STAFF RECOMMENDATION

751 Benton Avenue

August 20, 2014

Application: New construction-addition

Figure 1. 751 Benton Avenue

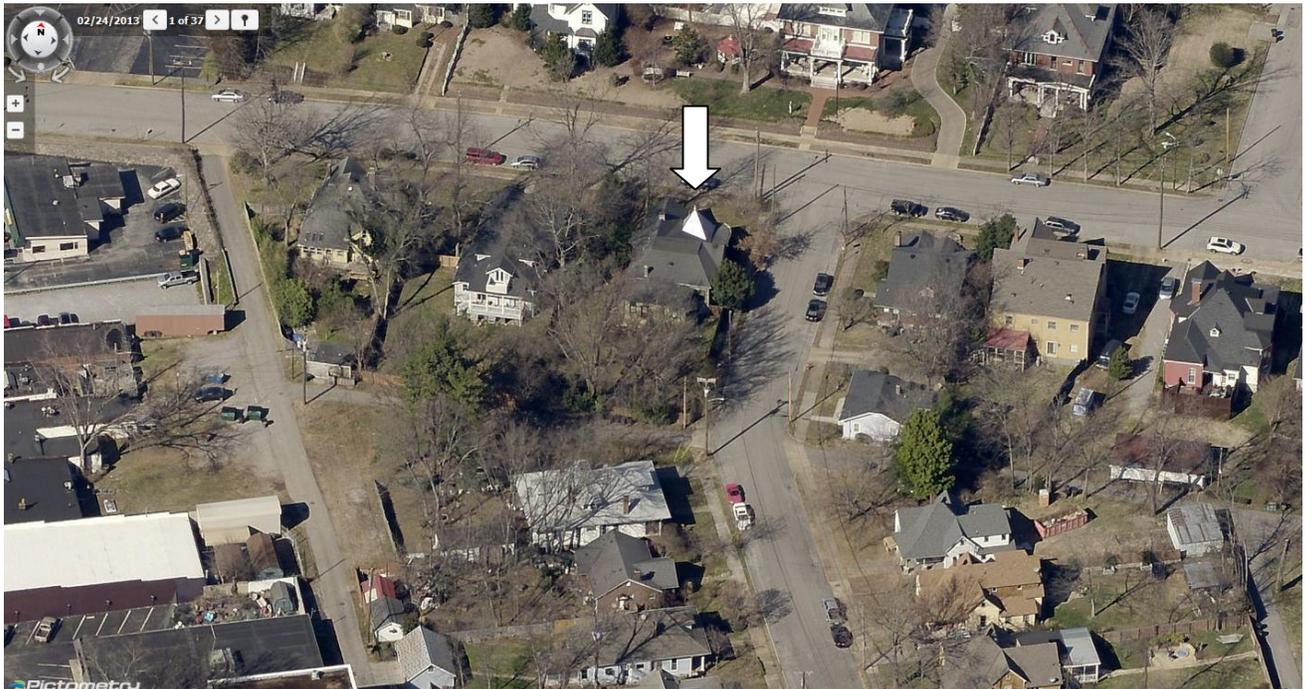
Background: 751 Benton Avenue is a contributing Queen Anne-style home that dates to 1910. It is a contributing building in the Woodland-in-Waverly Historic Preservation Zoning Overlay.

Figure 2. Non-historic addition and deck to be removed for the proposed addition

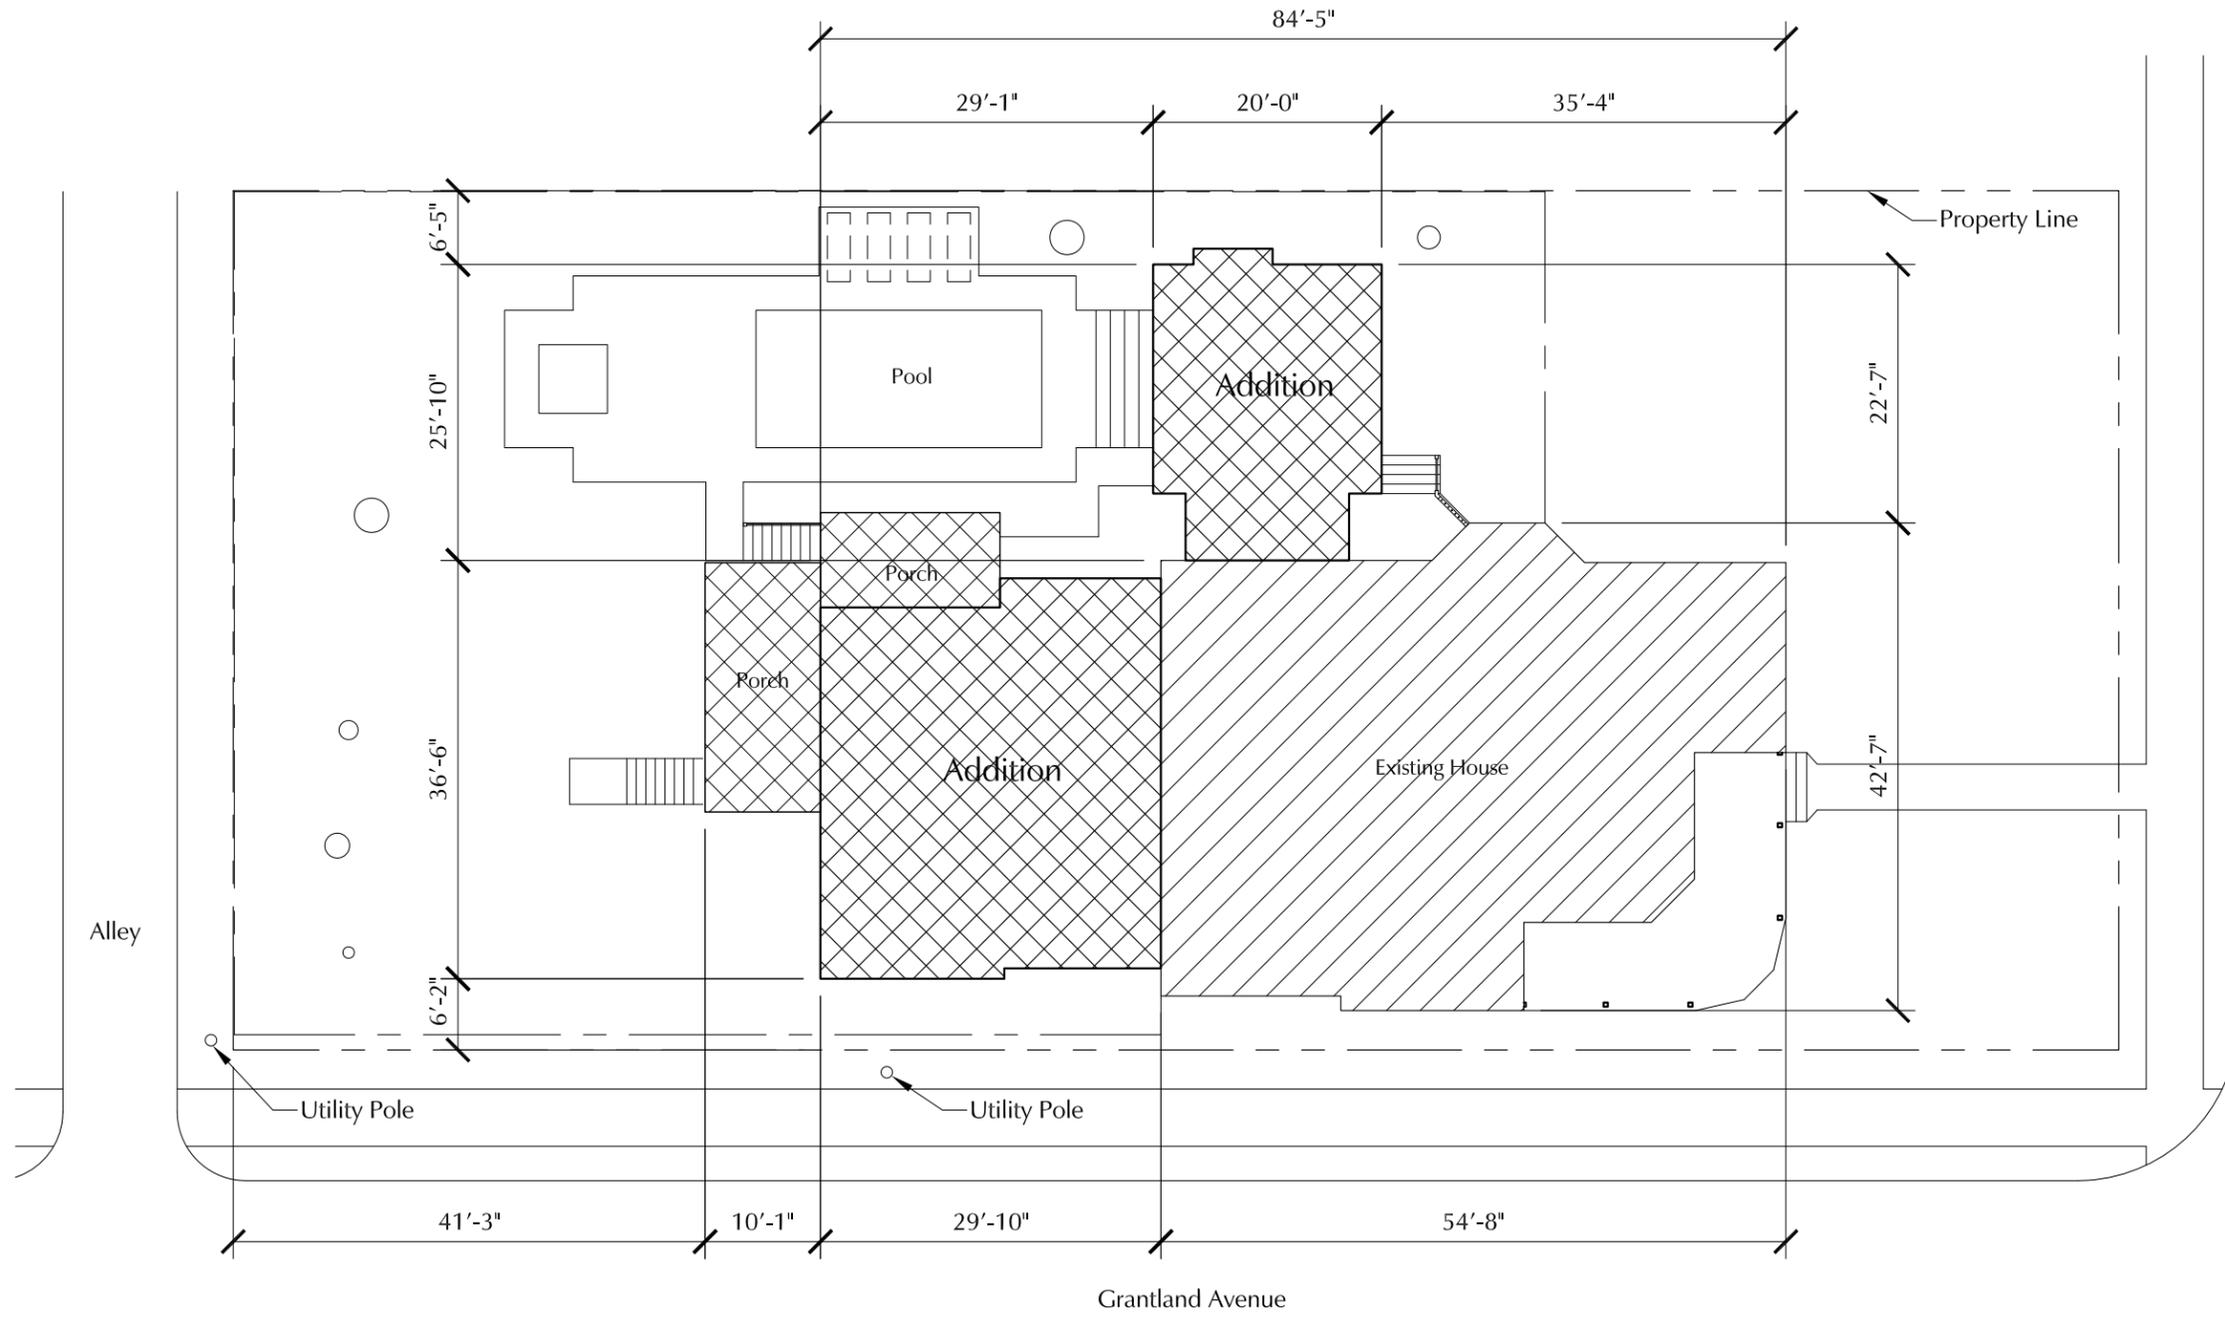
Demolition: This project calls for demolition of a rear deck, and a portion of the rear and right side of the house. A section of the right side wall at the rear is likely original to the building, but staff’s analysis is that the portions proposed to be removed do not contribute to the historical integrity of the house. A chimney at the rear will be removed, but this is not a character-defining feature of the historic house. This partial demolition meets section V.B.2 for appropriate demolition, and does not meet section V.B.1 for inappropriate demolition.

Drawings:
 Site Plan
 Date:
 08.04.14

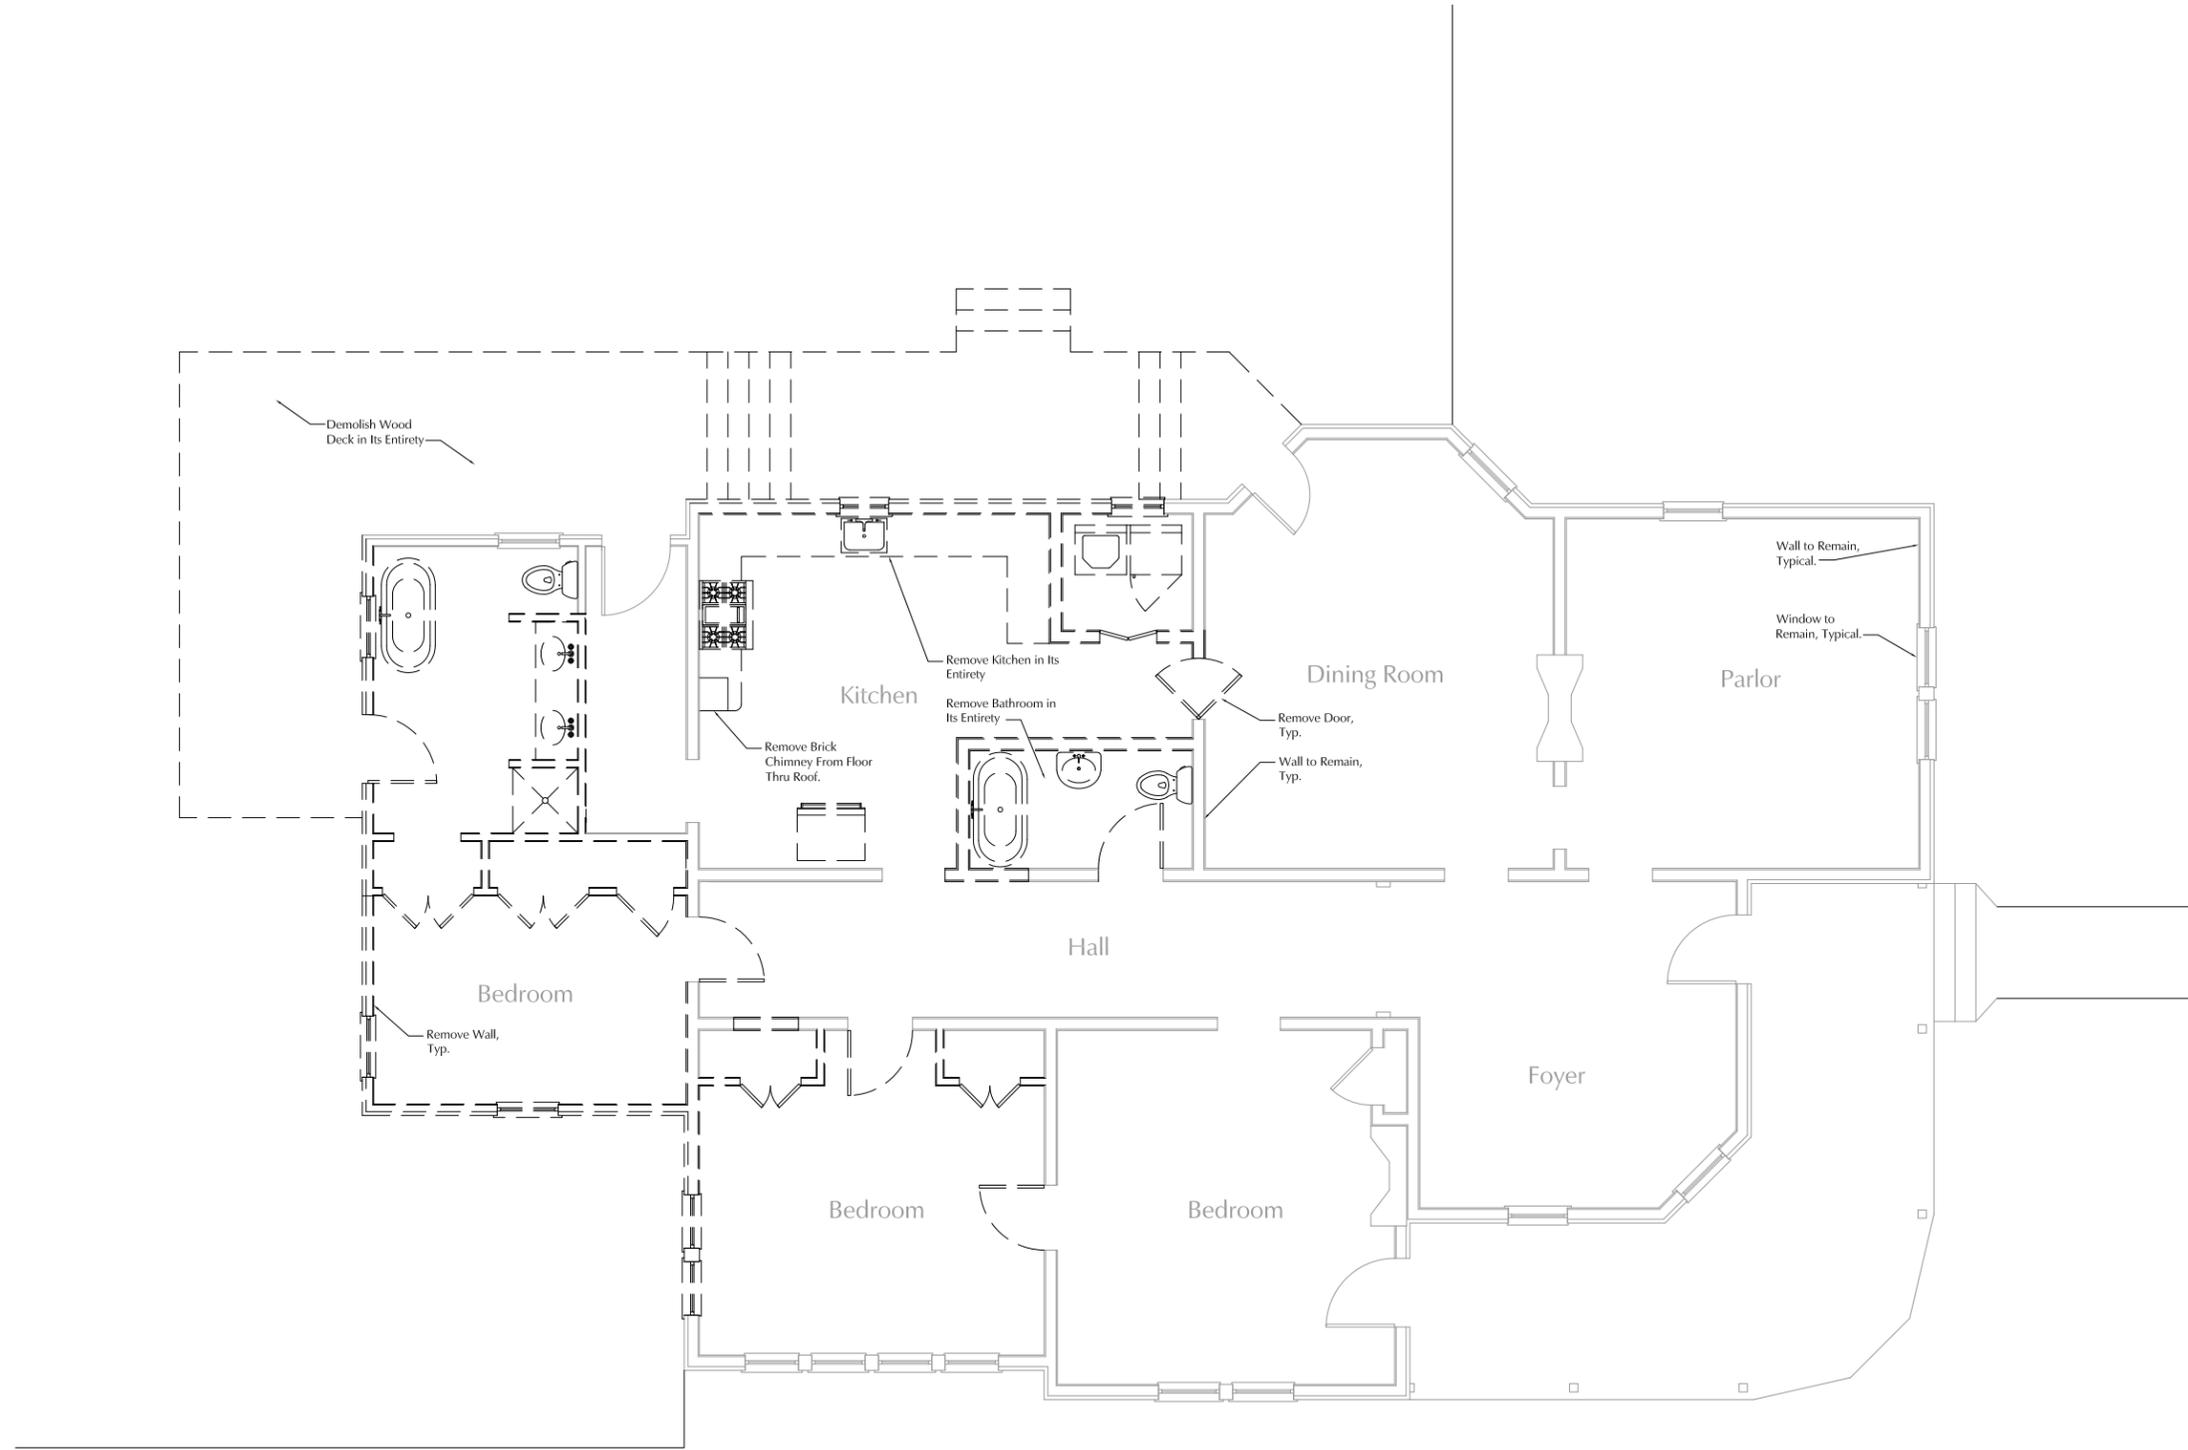
Setback & Rhythm of Spacing: The rear addition will be more than fifty-one feet (51') from the rear property line, and six feet two inches (6'2") and twenty-five feet ten inches (25'10") from the side property lines.

The side addition will be six feet and five inches (6'5") from the side property line and more than thirty-five feet (35') from the front of the house. It will not significantly impact the rhythm of spacing of the house along the street.

The proposed additions meet base zoning setback requirements of five feet (5') on the sides and twenty feet (20') from the rear, meeting sections III.B.1 and III.B.2.c. of the design guidelines.
